Historic Architectural Review Commission

Agenda Packet

Item 5.a.2.

5a-2 Request for demolition of non historic structures, new construction and restoration of historic house- # **911 Watson Street- Applicant: Matthew Stratton, Architect (H10-01-94)**

SITE PLAN / FLOOR PLAN
3/16"=1'-0"

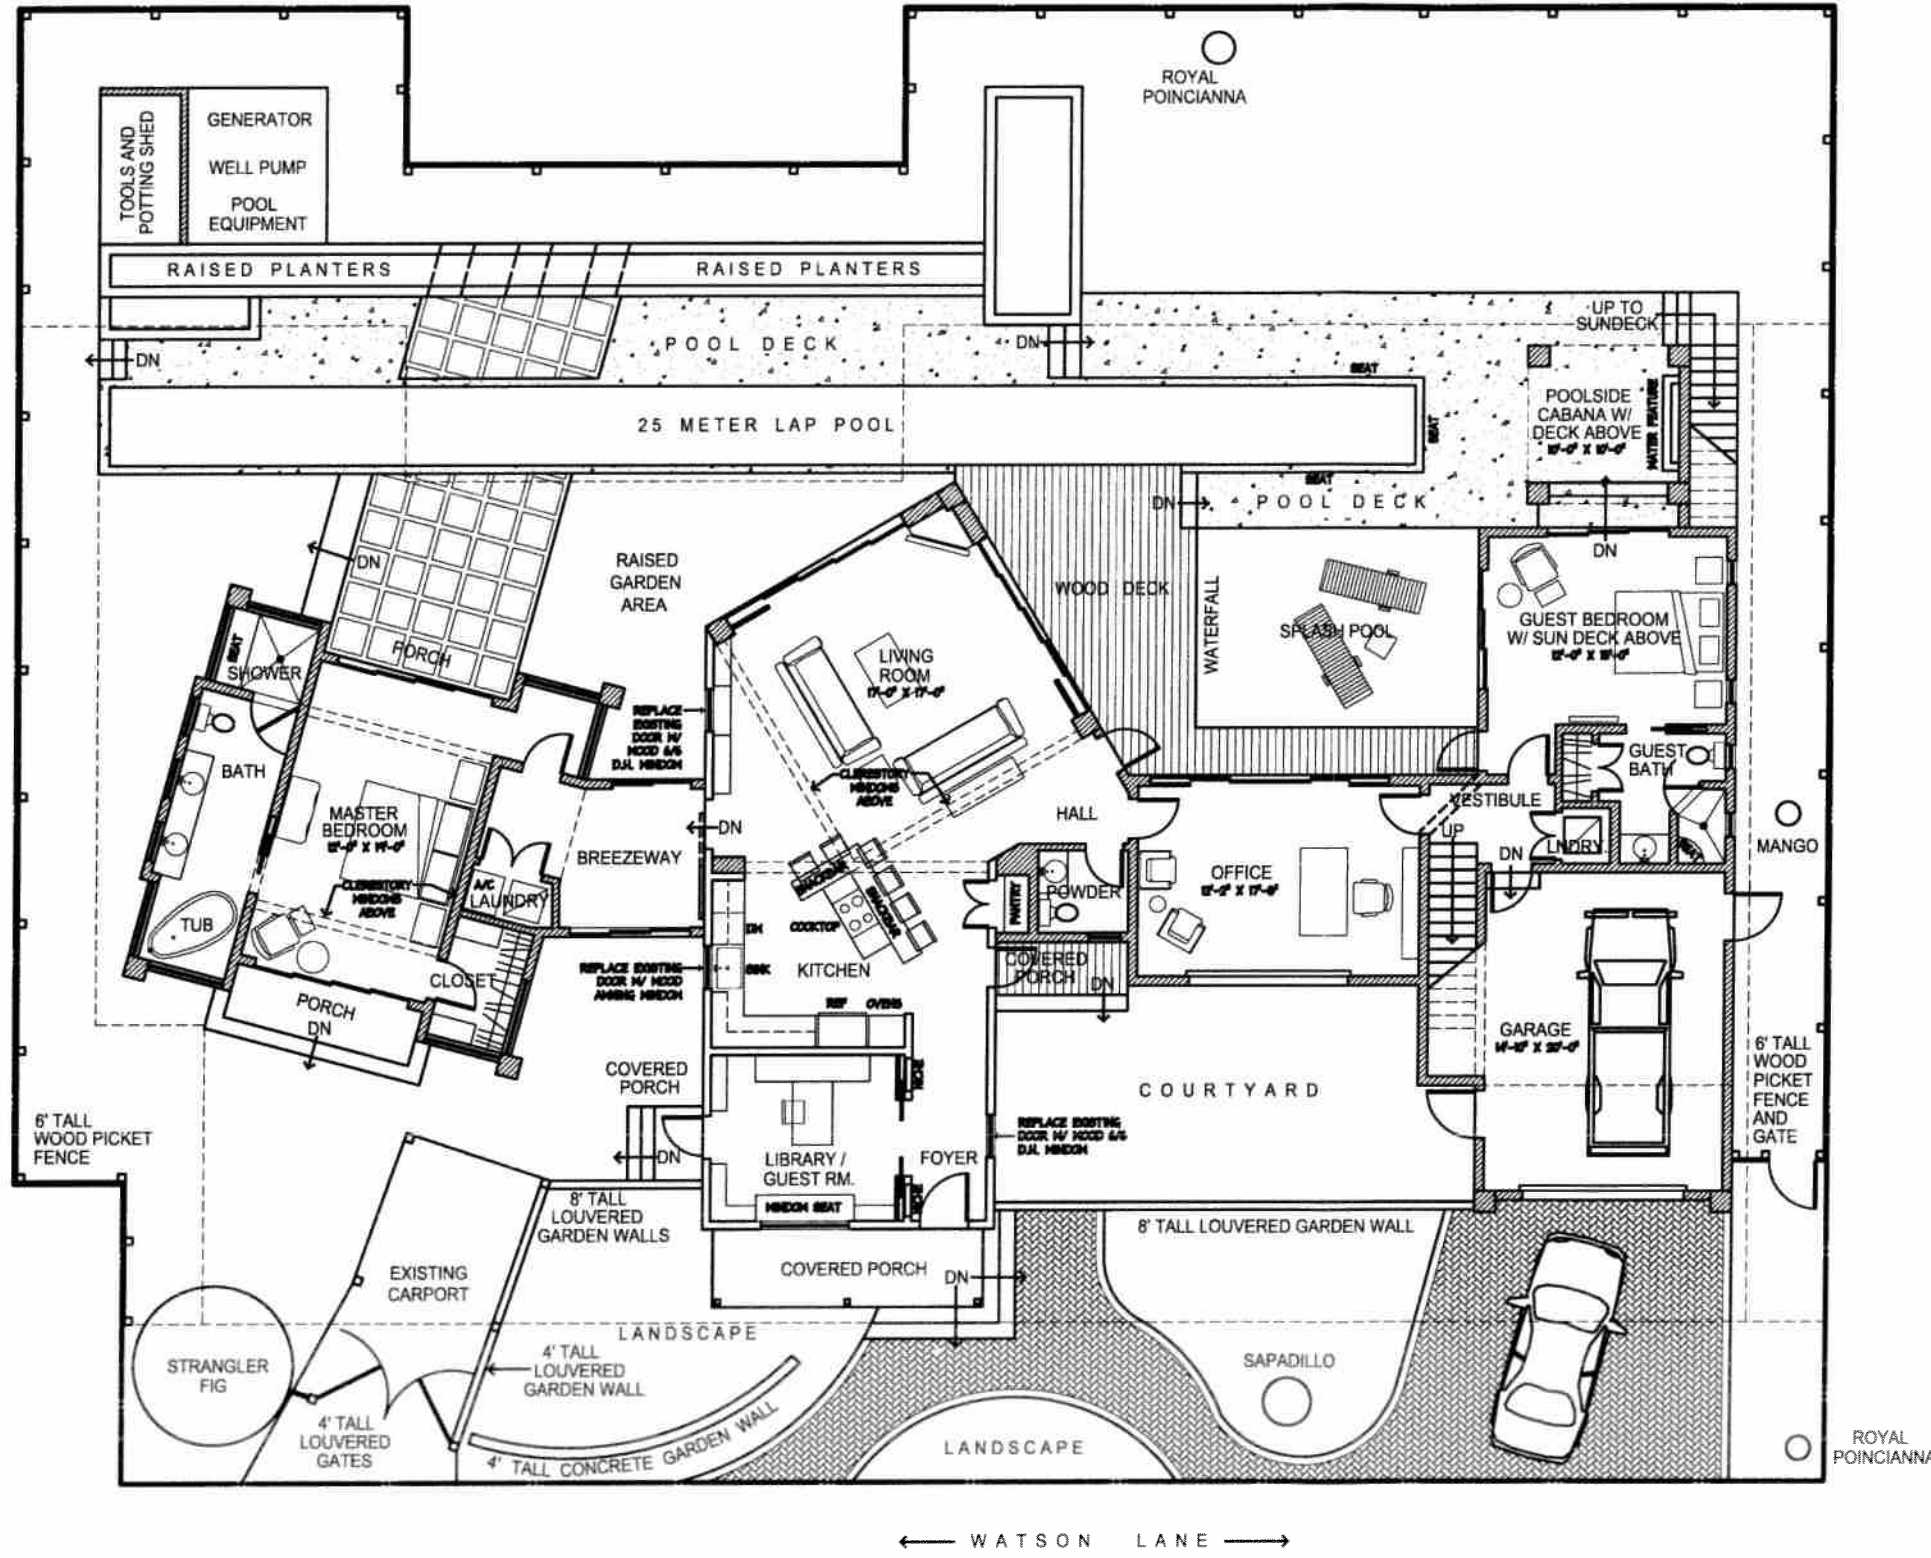
Nevertheless staff understands that the proposed raised planters will require a variance for back yard setbacks.

1. Proposed raised planters on the back can be lowered to meet maximum height requirements for fences and walls in the guidelines.
2. Revision of the proposed observation deck over the cabana.

Nevertheless staff understands that the proposed west awning of the cabana will require a variance for back yard setback. Staff also understands that the eight feet front garden walls and the proposed raised planters will also require variances.

- *(5) Solid six foot fences with abutting vertical boards are permissible on side and rear elevations if adjacent owners have signed notarized statements of agreement- It is staff believe that the proposed ten feet and twelve feet proposed planters constitute a wall and does not comply with this particular guideline.*

The applicant does not anticipate the need for any variances.

Again, I do not believe that this guideline pertains to the proposed raised planters. The planters are considered an integral part of the swimming pool design, and there are separate 6' tall fences proposed for "separating or enclosing or defining space" at the sides and rear property line. The planters are designed to meet swimming pool and/or accessory structure setback requirements. Why would I be allowed to construct an accessory structure such as a shed or a garage at the proposed planter location, but not a planter?

It is my belief that the raised planters better fit the definition of *“accessory structure”* than *“fence”*.

The proposed raised planters were designed to meet the requirements of an accessory structure.

EAST (FRONT) ELEVATION

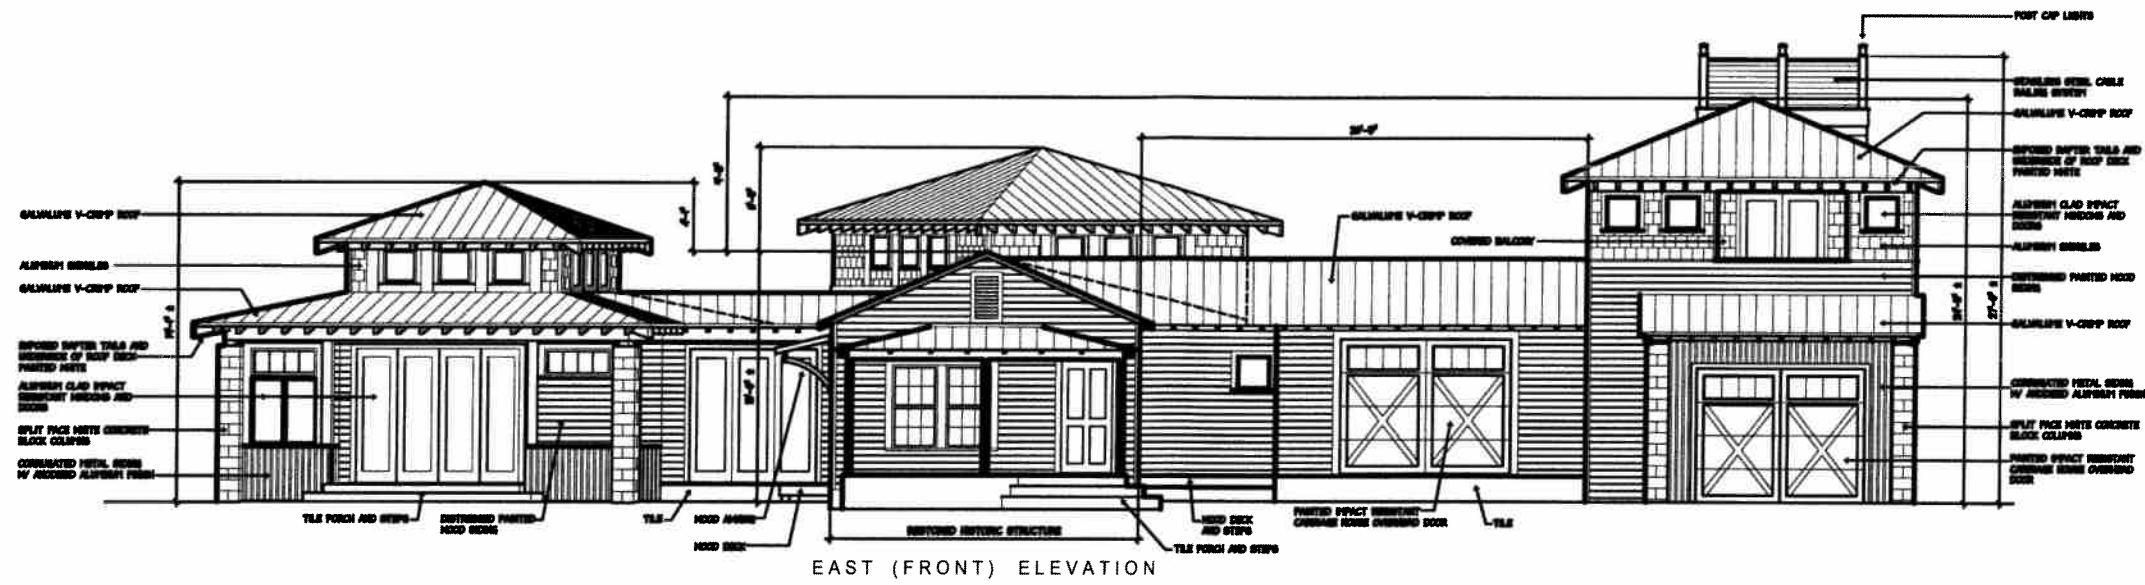
Staff understands that the proposed eight feet height louvered garden walls do not comply with this guideline. These garden walls are free standing structures intended to separate, enclose or define a space; this is part of a fence definition in the City Code (Chapter 86.9). It is clear that in the plans the front eight feet tall louver garden wall located to the north side of the main house is used to create a courtyard, while the 8 feet tall louvered garden wall on the front south side of the main house serves the utilitarian purpose as to control ingress or egress to the property. It is staff believes that the proposed height of these garden walls is inconsistent with the guidelines.

1. Eight feet height louvered garden walls proposed on the front can be lowered to meet the height requirement for fences and walls in the guidelines.
2. Proposed raised planters on the back can be lowered to meet maximum height requirements for fences and walls in the guidelines.
3. Revision of the proposed observation deck over the cabana.

CORRECTION / CLARIFICATION: The louvered garden walls are to be constructed of wood, not metal.

NORTH SIDE ELEVATION

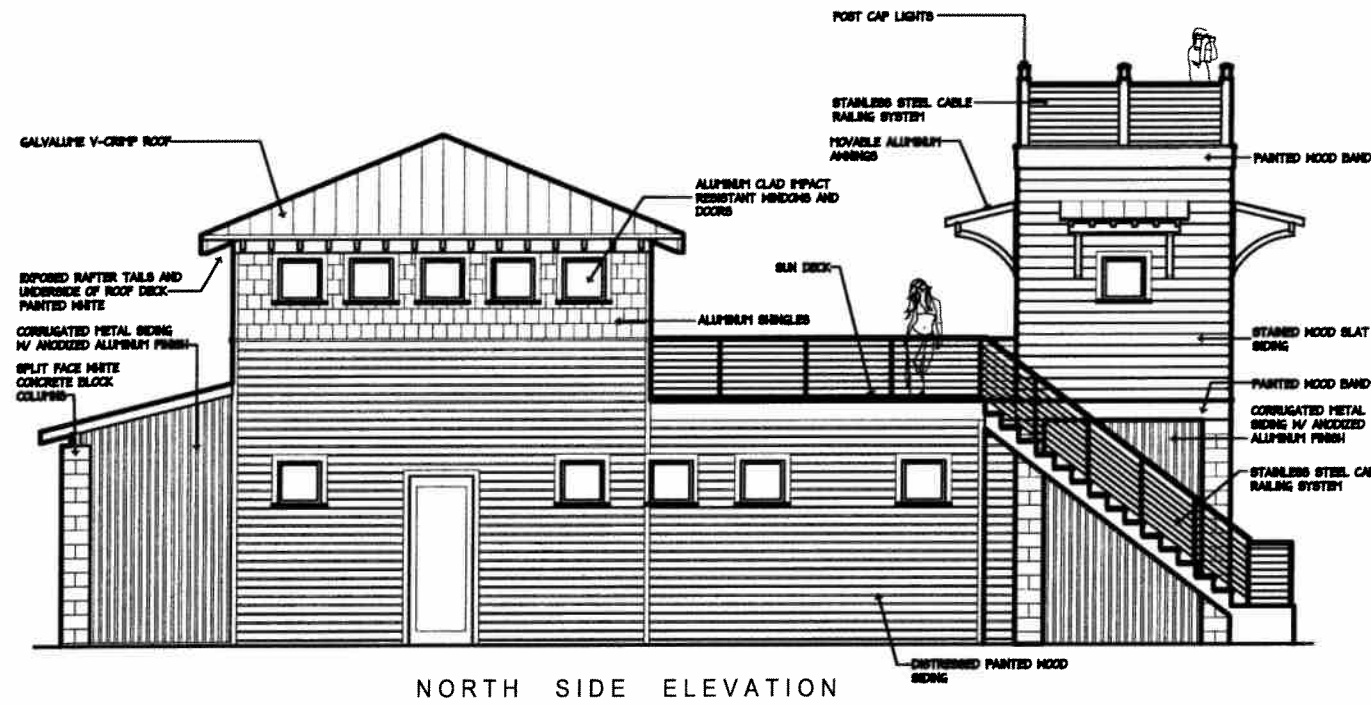
Staff understands that an observation roof proposed over a tower will outsize the majority of structures in the streetscape or historic zone. This site is close to the cemetery and staff understands that this observation tower will be visible from it.

Staff also wants to review the proposed observation deck over the cabana by applying the guidelines for widow's walks and roof decks (page 28);

While the proposed design does not fully meet the definition of "Widow's walk" listed in the architectural glossary, I do believe the proposed design meets the guideline on page28 that states:

"Widow's walk additions and roof decks must be compatible in scale and design with the existing structure."
